13 June 2025
The General Manager
Northern Beaches Council
Civic Centre
725 Pittwater Road
DEE WHY NSW 2099

**DEVELOPMENT APPLICATION REFERENCE DA2025/0572
DEMOLITION WORKS AND CONSTRUCTION OF A DWELLING HOUSE INCLUDING A
SWIMMING POOL
24 OGILVY ROAD, CLONTARF**

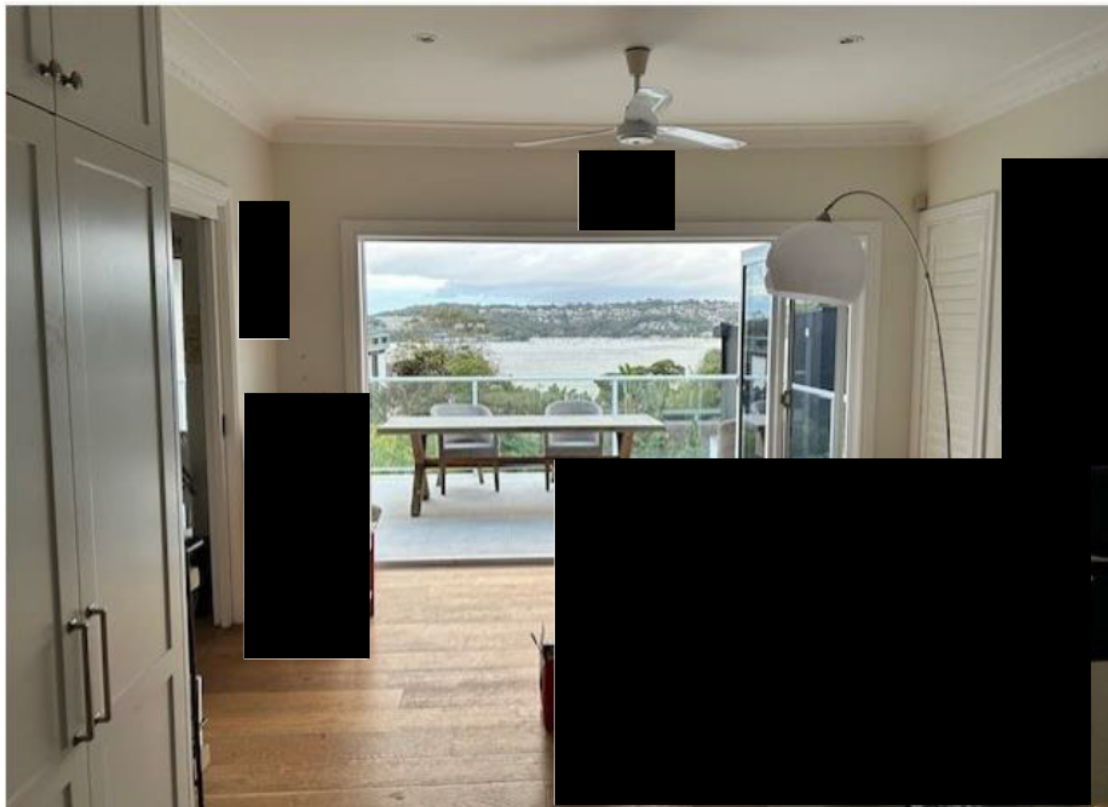
39 Cutler Road takes in whole views of the Harbour and surrounds, Balmoral Beach and the iconic heritage listed Balmoral Bathers Pavillion.
